## S E R V I C E N O T E

**3708A Noise and Interference Test Set**

Serial Numbers: 0000U00000/2515U00778

**PROM Retrofit Kit to be used as a Preferred Replacement for PROM Failures****To Be Performed By:** Agilent-Qualified Personnel**Parts Required**

**Figure 1**

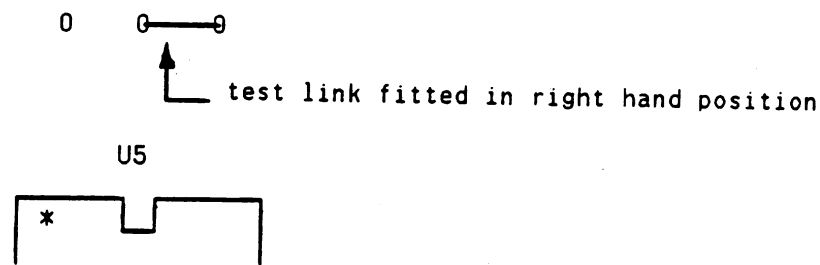
Step 1 is only required when replacing PROM's from firmware revisions 2506 and 2510.

1. Change the test links on the A201 Microprocessor Assembly TL2,4,5 and 6 to the right hand position as shown in Figure 1.

2. Fit the PROMs from the retrofit kit as follows:
  - a) 03708-80065 at location A201U5.
  - b) 03708-80066 at location A201U6.
3. Carry out Operation Verification Test 4-13 SWITCH ON and note that the 3708A front panel left hand display indicates 3603.....the new firmware revision.
